Model: PRIPORT HP4/HP4P			Date: 30-Sep-03	No: R-C249-001a	
Subject: HP4/HP4P firmware history			Prepared by:		
			A. Yoshida, Priport Service Pla	anning Section	
Classification:	Troubleshooting	□ Part information     □ Part inform	☐ Part information ☐ Action I		
		☐ Electrical	☐ Servi	ce manual revision	
	☐ Paper path	☐ Transmit/rece	eive 🗌 Retro	fit information	
	☐ Other ( )				
Model Name:					
HP4:	Ricoh JP4500, Gestetner CP6244, RexRo Savin 3560DNP, Standard SD420, Lanier			atec CP6244,	
HP4P (China only):	Ricoh JP4510P, Gestet	nei 6254P

Model: PRIPORT HP4/HP4P			<b>Date:</b> 1-Oct-03	<b>No:</b> R-C249- <b>002</b>	
Subject: Firmware Modification History - Printer			Prepared by:		
controller unit			M. Ohtsubo, Priport Service Planning Section		
Classification:	☐ Troubleshooting	☐ Part informati	on	required	
	☐ Mechanical	☐ Electrical	☐ Service	e manual revision	
	☐ Paper path ☐ Transmit/rece		eive 🗌 Retrofi	t information	
		tion History)			
Model Name:					
HP4:	Ricoh JP4500, Gestetner CP6244, RexRotary CP6244, nashuatec CP6244, Savin 3560DNP, Standard SD420, Lanier LDD145			ec CP6244,	
HP4P (China only):

Model: PRIPORT HP4/HP4P			Date: 5-Nov-03	<b>No:</b> R-C249- <b>003</b>

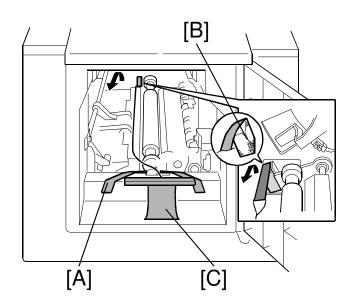
Strips of tape and a styrene foam sponge have been added as shown below to secure the Press Roller during transport. <u>Please be sure to remove the tape [A], sponge [B] and tag [C]</u> by pulling the portion shown in the diagram toward the front of the machine <u>before beginning machine operation</u>. If they are not removed:

- Paper jams or blank images may occur, due to the lack of pressure on the Press Roller.
- The tape may stick to the drum screen or Press Roller.

### **Master Clamp Guide Replacement Procedure**

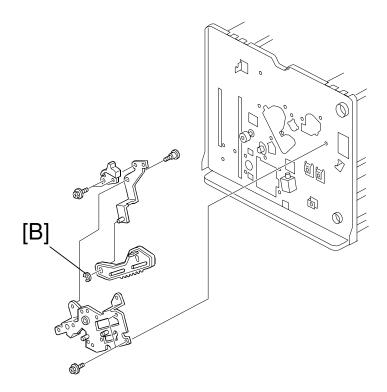
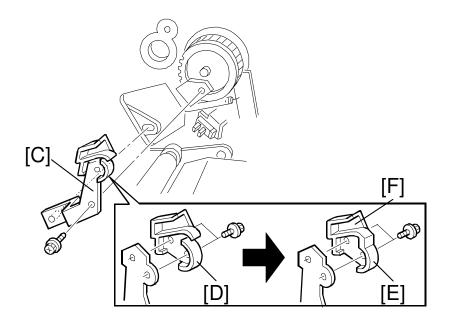
Replace the master clamp guide with P/N C2494058 (see MB #C249004).

- 1. Turn off the main switch and disconnect the power plug.
- 2. Remove the rear cover [A] ( $\hat{\mathscr{F}}$  x 5).

3. Remove the E-ring [B] ( $\mathbb{C}$  x 1).

- 4. Remove the drum unit.
- 5. Remove the lever [C] ( F x 1).
- 6. Remove the master clamp guide [D] from the lever [C], then replace it with the new master clamp guide (P/N C2494058) [E] ( F x 2).
- 7. Apply grease (P/N 52039502) to area [F] on the new master clamp guide as shown below. **NOTE:** Please be sure to use the grease type mentioned above.
- 8. Reattach the lever [C] ( F x 1).

- 9. Reattach the E-ring [B] ( $\mathbb{C}$  x 1).
- 10. Reattach the rear cover [A] ( $\mathscr{F}$  x 5).
- 11. Reinstall the drum unit.

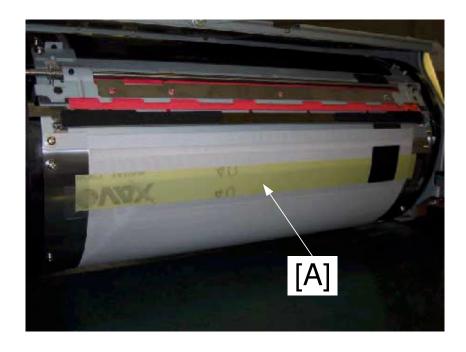
The color of the sandpaper [A] on the cloth screen was changed back to similar to its original color from Aug 2004.

**Reason:** In June 2004 machine production (July color drum production), the color of the sandpaper was changed to yellow because of a vendor change. This was confusing to some technicians and customers, so the sandpaper was changed back to similar to its original color.

**Change applied from:** Aug 2004 (machine and color drum production).

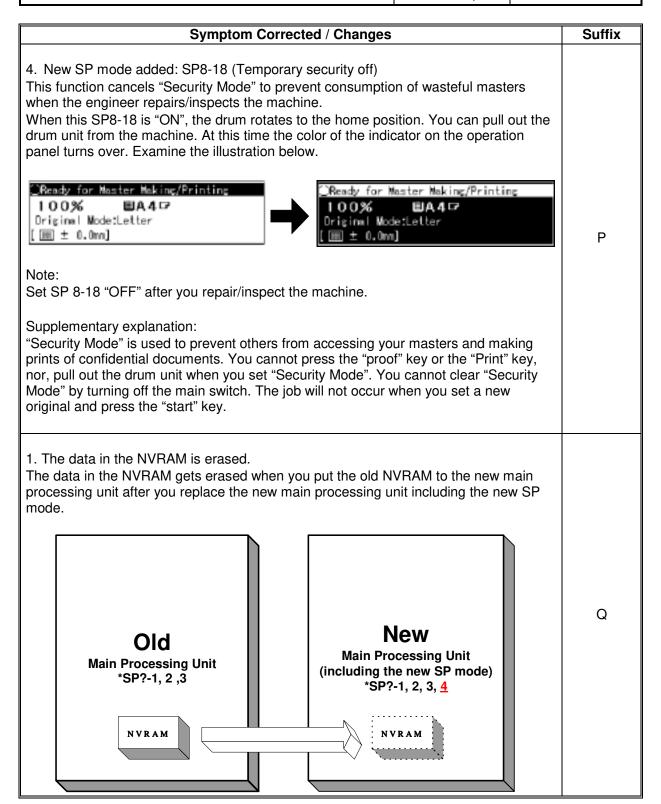
1. Image shifting due to incorrect ADF paper loading: Firmware modified so that once the ADF detects a defined paper size with the left (innermost) paper length sensor [A], or neither of the sensors, it will not switch over to an "undefined size". if something is placed on top of the right (outermost) length sensor [B].  Example: Machine will not switch to "undefined size" even when a sheet is placed on the right length sensor after it has detected an A4 LEF sheet.	P

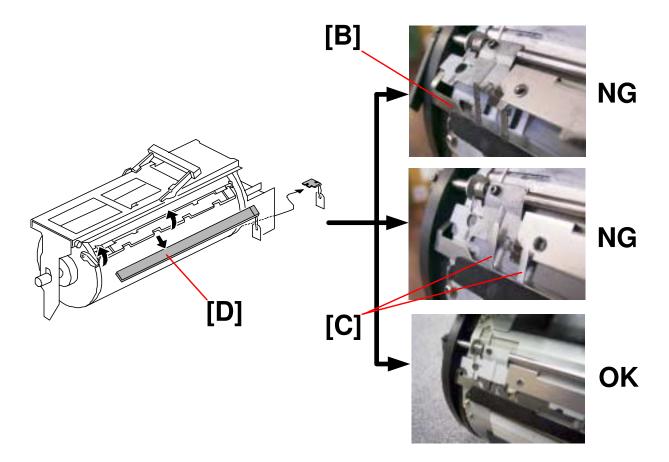
2. The master clamper [B], [C] is set in the wrong direction when the filament tape [D] is removed at machine installation.

**Note:** Incorrect = The clamper's lower teeth are on the outside.

- The new firmware automatically opens/closes the clamper at certain times to make sure it stays closed in the correct position.
- For details, see RTB #RC249001c.

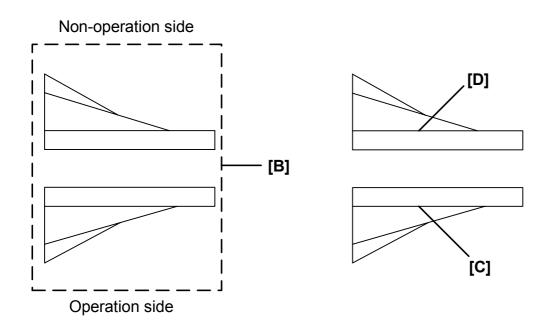
The shapes of the air knife fan, fan bracket, delivery belt and air knife duct have been changed to ensure the proper paper delivery.

Connector Number - Section D (pg. 7-6)

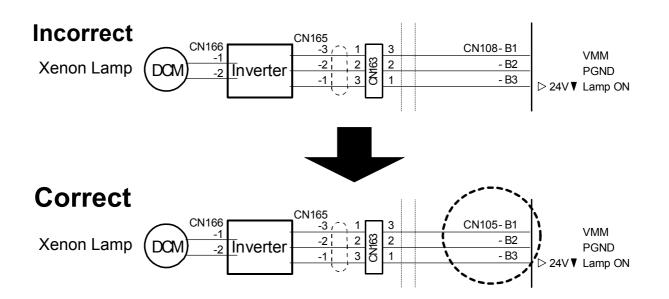
The Service Manual was corrected as follows.

#### Important Note for when Replacing the Mylar Seal

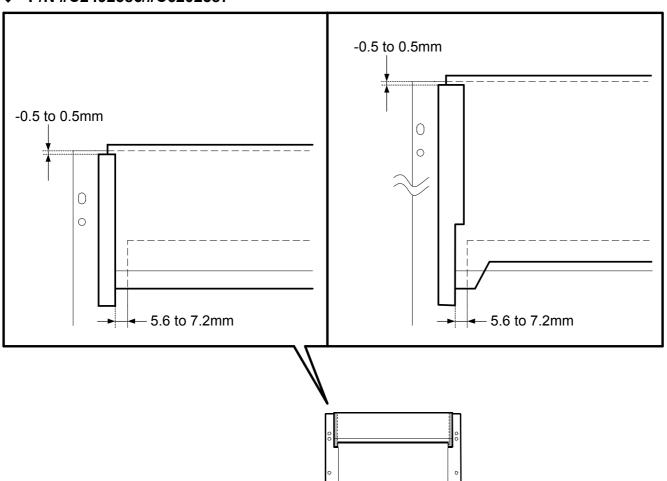
If you replace only the Mylar seal, make sure to clean the attachment area with isopropyl before you attach the new seal.

#### 7. POINT TO POINT DIAGRAM

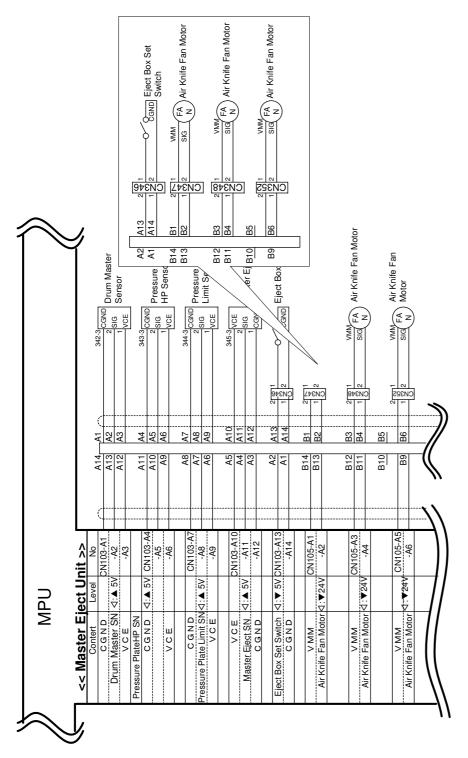
The number of air knife fan motors was decreased from 3 to 2. CN347 is not used to connect the air knife fan motor on the B4 model.

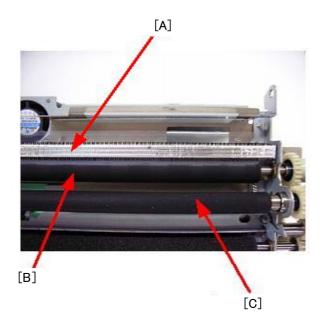
Dust [D] causes the burr on the guide sheet [A] to contact the front tension roller [B], which slows down the master feeding speed. The master is then cut short the next time it is fed.

- 1. The burrs on the guide plate were bent so that they will not contact the tension roller.
- 2. The thickness of the guide sheet was decreased from 0.1mm to 0.075mm, which decreases the pressure on the tension roller.

Install the new Guide Sheet (P/N C2642050) or Guide Plate Ass'y (P/N C2642051).

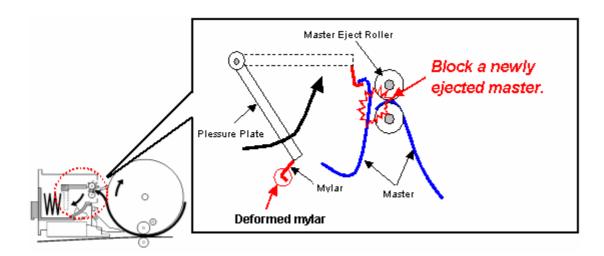
- 1) Change to the new master eject box. See MB MC264-010 for parts information.
- 2) (A). Remove the two cushions on the master eject box. Then, apply silicone grease/oil to the front side of the master eject box.

**(B).**Replace the Mylar on the side of the pressure plate if it is deformed.
